Docket Item # 5
BAR CASE # 2016-0114

ISSUE: Park improvements

APPLICANT: City of Alexandria Department of Project Implementation

LOCATION: 421, 500, 500A, abutting parcel south of 500A, 501, 520 & 600 S Union Street (Windmill Hill Park)

**Pedestrian Bridge –
Option 1**

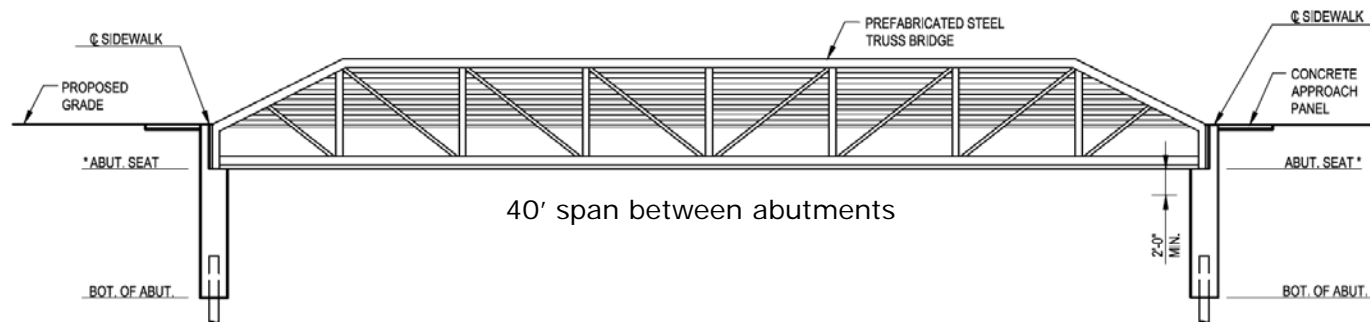
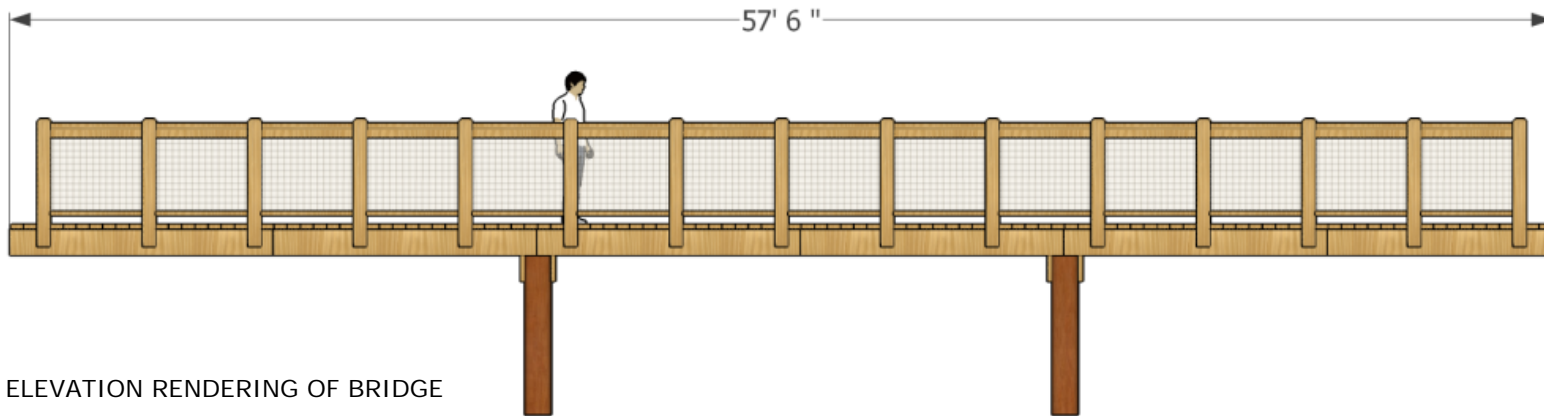
Because of the broadly stated purpose and standards in the zoning ordinance and function of the *Design Guidelines*, the BAR is reminded that there are often multiple *appropriate* design solutions. Staff continues to find that the first metal bridge, with a more industrial character and truss system, is appropriate for this previously industrial site. Staff thinks that such a design will reference the long-standing industrial and railroad uses found on this site and does not believe that just because the bridge has been used in one other location in the city, that it is inappropriate here. Additionally, DPI has noted that an arched form could be incorporated into this option, thereby making it more unique to this particular park in the City. This design also clearly reads as a bridge, much more so than the wood pier version of the bridge. The pier option of the bridge is the least successful, in staff’s opinion, taking a plainly utilitarian approach to what could be a feature element in the park. Staff also appreciates that DPI has continued to explore options for this element and submitted Option 3, a timber bridge than can either be flat or have a slight arch. Staff also supports this option, finding it to be compatible and appropriate as well. **Therefore, staff recommends that both Options 1 and 3 are appropriate and be included as options, with final design details to be worked out with staff following the Board’s input.**

Bridge Elevation, as previously submitted, can be modified to incorporate arched truss, per BAR comment.

Stone Seat Walls

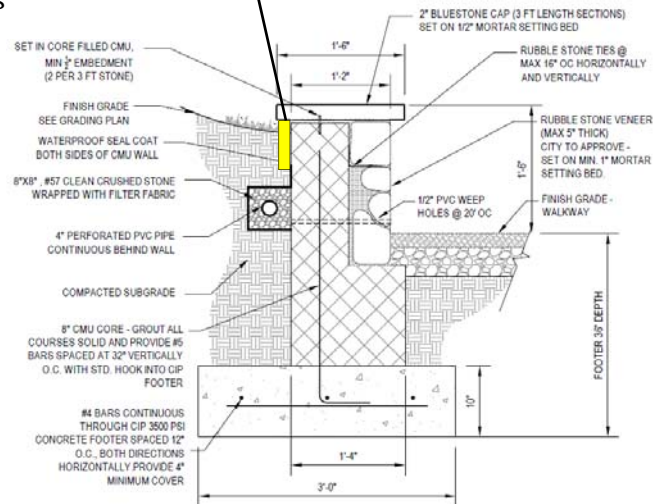
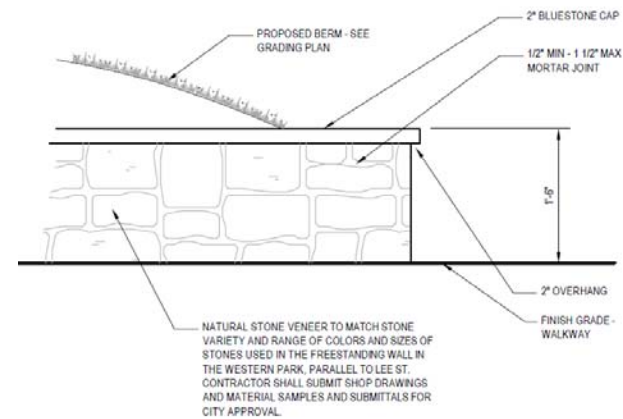
In response to the BAR's concern that the CMU substructure would be exposed over time, the applicant will revise the construction drawings to require that the stone veneer be installed at least 4-8 inches below grade to prevent exposure of CMU block. BAR staff will review compliance with this during building permit review.

Added single course of stone veneer,
per BAR comments

Site Lighting – Gadsby Pole Replacement
Interim light pending W.F. Common Elements light selection.

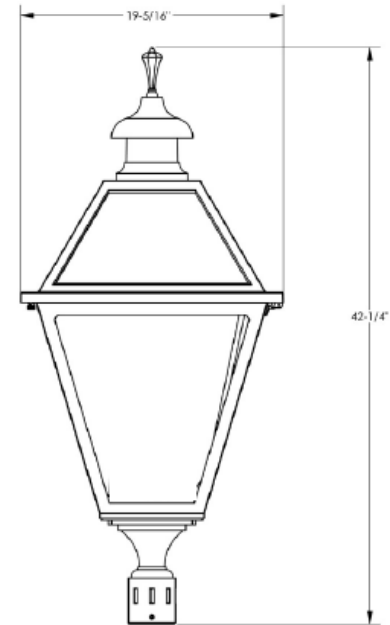
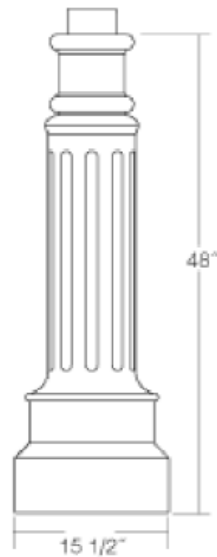
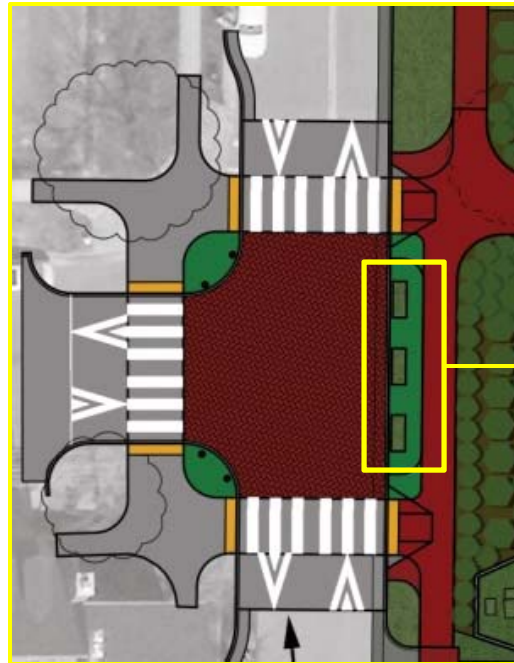
The programmatic requirements of the project scope require replacing existing streetlights on the northern path and installing limited new streetlights where there are seating areas for safety purposes. Staff finds this lighting scheme to be a modest level of illumination that will continue the natural feel of this particular park while providing appropriate lighting for overall safety. It should be noted that the specification of Gadsby streetlights in the park is an interim proposal until the Waterfront Common Elements palette is approved. Concurrently, the City is in the process of selecting an appropriate Gadsby Replacement Streetlight that will be more historically accurate, much more energy efficient, and substantially less cost to replace. As part of the Gadsby Replacement Streetlight project and the Waterfront Common Elements, there has been discussion and general consensus that the Gadsby Streetlights should be true streetlights and used only on streets. While the existing Gadsby Streetlights are found all over Old Town, and in some curious locations, it is quite likely that the intention going forward will be to be more conscientious in determining where they are installed. It is expected that the BAR will review the Waterfront Common Elements palette and replacement Gadsby streetlight for separate Certificates of Appropriateness in September 2016. Specific comments and design direction for these items should be made at that time.

The Waterfront Common Elements will include a unique promenade light that will be used to visually link the public path along the entire length of the waterfront. In the future, as each waterfront park is fully designed, there may be additional lighting options for other areas in the interior of the parks, street-end gardens and piers. Because the Gadsby Streetlights are by function and aesthetics a more traditional streetlight, staff recommends that an alternate light, consistent with the Waterfront Common Elements palette be used within Windmill Hill Park. The use of lights from the Common Elements for the pathway and seating area will also knit this particular park into the overall waterfront park program and further connections along the waterfront. Staff recommends that once the Common Elements are approved, the selected promenade light should be used in the limited lighting areas in Windmill Hill Park, adjacent to the path, as the character of this area is more similar to the park promenade in Founders Park and Oronoco Bay than an Old Town street. Should the final promenade light not be selected in time for the construction at Windmill Hill Park, the replacement Gadsby streetlight may be installed *only* as an interim condition.

Gadsby Pole replacement model shall be used as an interim condition until Waterfront Common Elements are finalized and lighting master plan is complete.
